Quality Control Check Report. Stage: After Finishing Stage III (Apartments)

Flat No	C-502	Other	—	SL No.	42958
Company	MRM-LLP	Project	GMR	Phase	
Prepared by	Abhishek Gautam	Sign		Date	28-5-24
Project Manager	Srinivas	Sign		Date	28-5-24
Previous stage report no.	42945	MD Sign		Report filed and signed by PM	☒ Yes ☐ No
Checked By MD on		MD Sign		For filling	☐ Yes ☐ No

Details of Additions & Alterations

WORKING PLAN-1660 Sft - B2 TYPE:

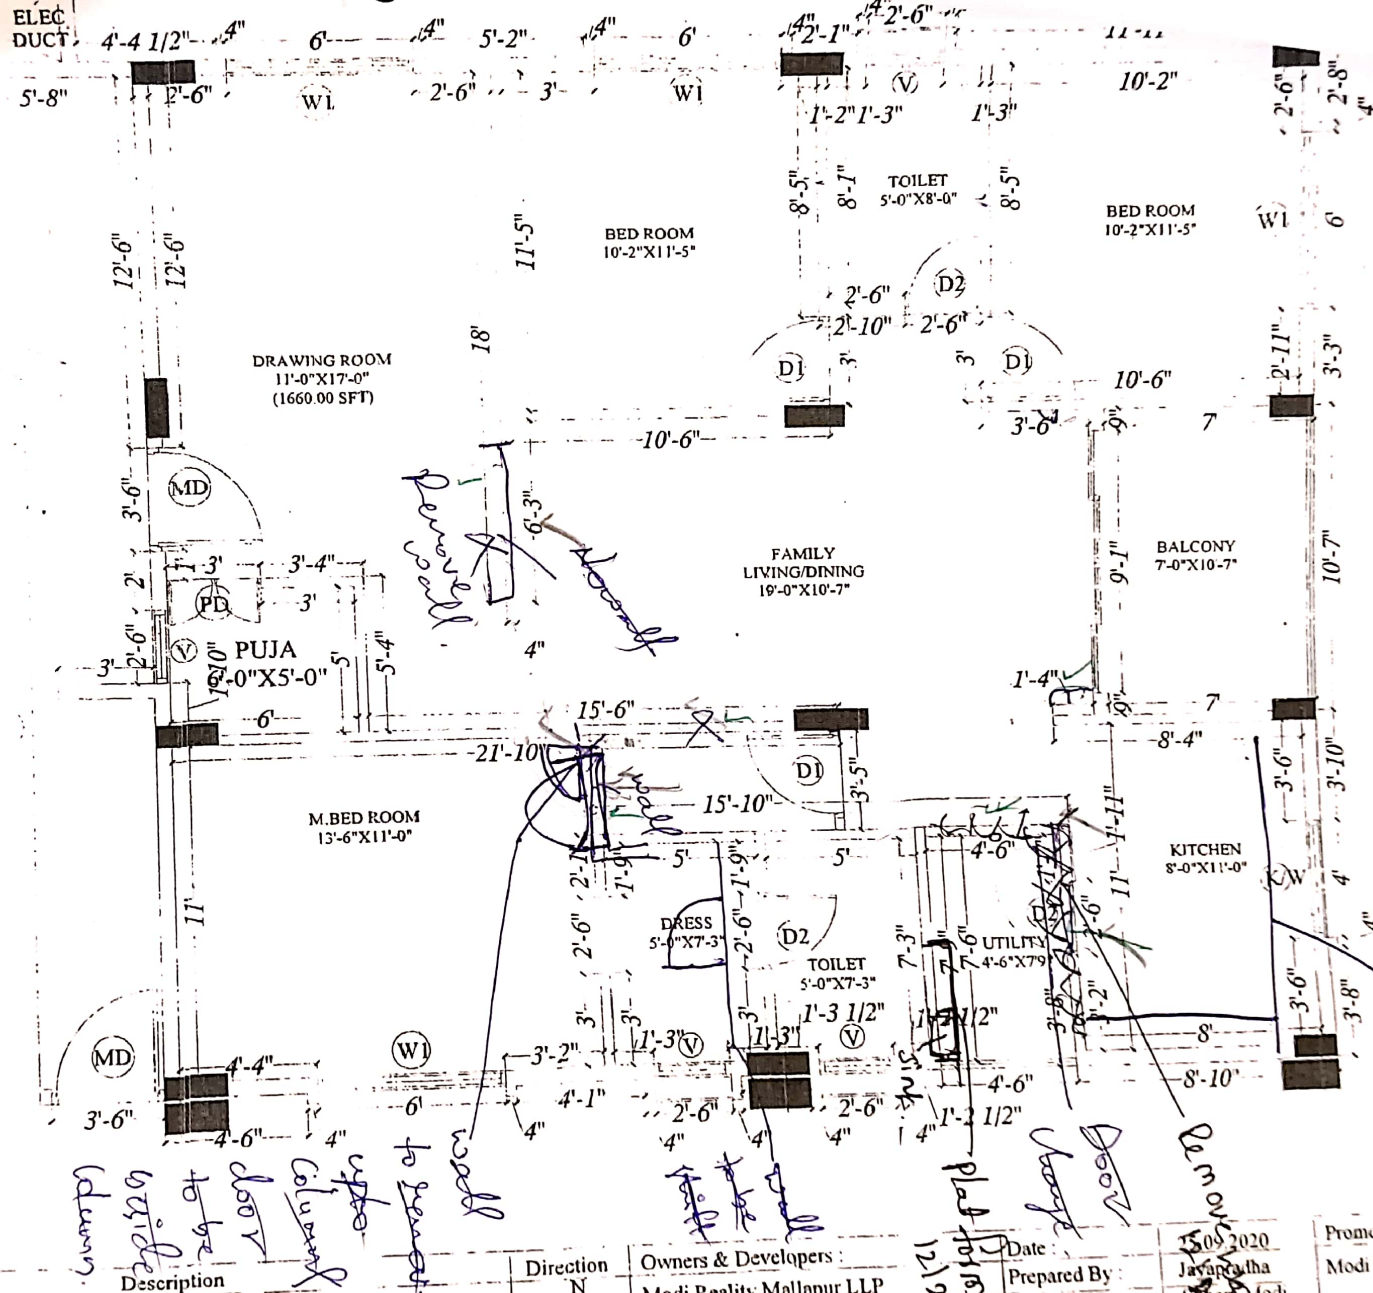
- Hot & cold water taps to be provided for both toilets sinks
- Wall of M.B. to be removed upto column & ~~to~~ door to be changed
- Wall near trench door to be levelled upto column ~~thickness~~ - both sides.
- M.T. door opening to be changed & showed in plan.

ELECTRICAL PLAN - 1660 Sft - B2 TYPE

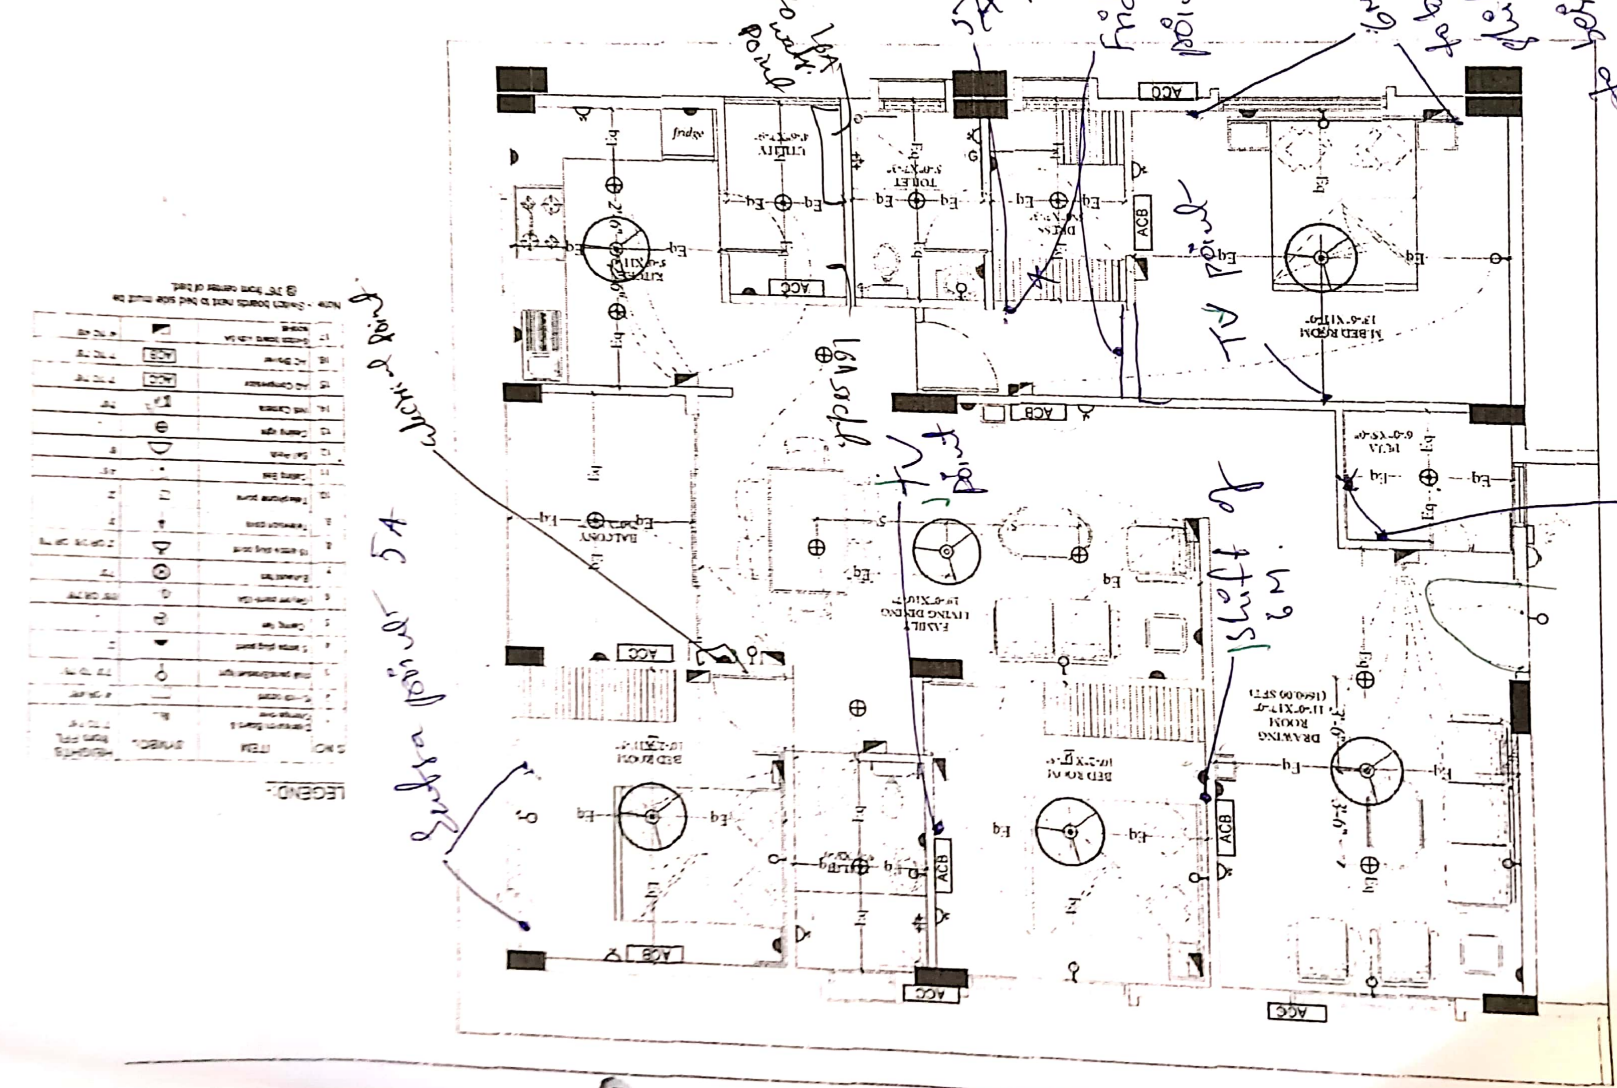
- Shift of panel at 12m
- Shift of panel at 12m
- Shift of panel at 12m
- Shift of panel at 12m
- Charge of panel
- 6m

Description	89	Direction	Owners & Developers
CC-B-BLOCK-FLAT ELECTRICAL PLAN - FLATS NO 2 & 3			Modi Realty Mallapur LLP
			Project Name 2 Phase
			Location

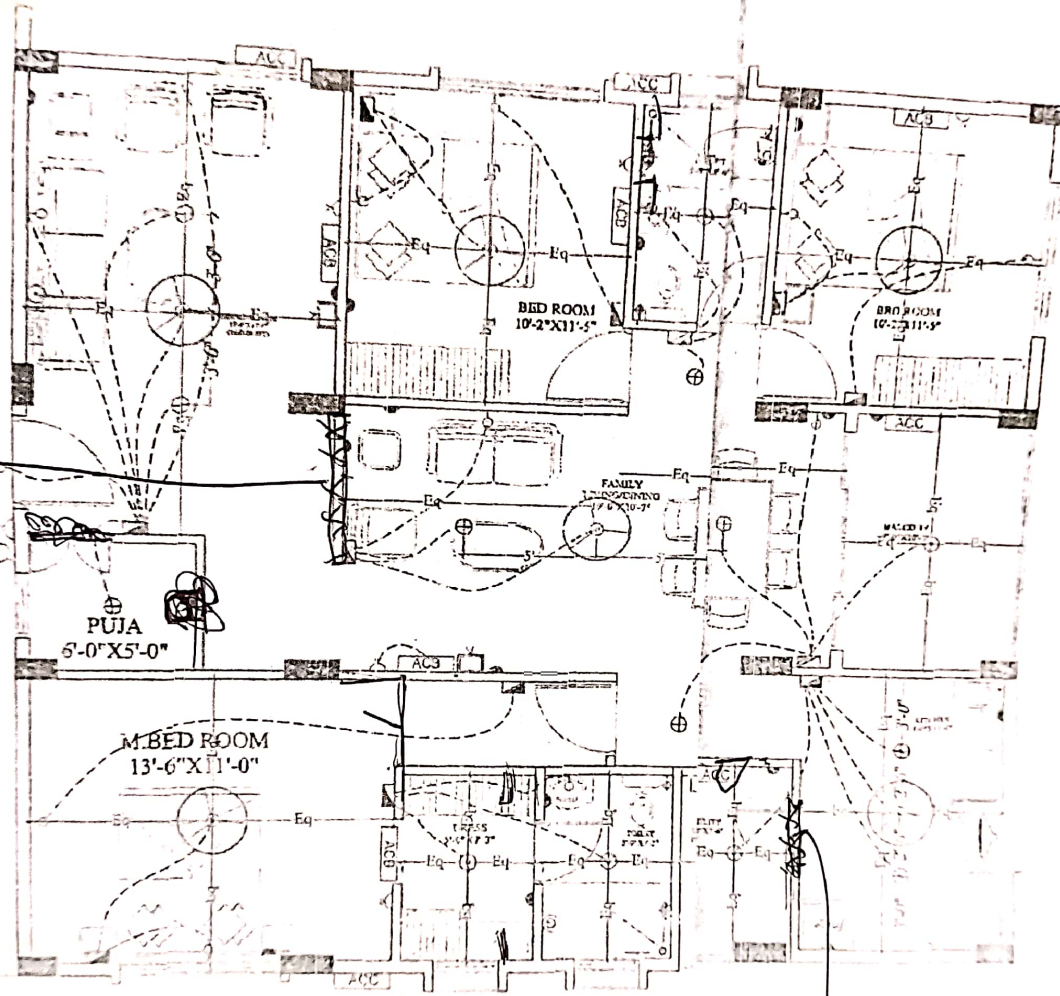
- Handwritten: "wall required" with an arrow pointing to a wall section.
- Handwritten: "8/2/23" and "8/2/23" (likely dates).
- Handwritten: "8/2/23" (likely a date).
- Handwritten: "8/2/23" (likely a date).
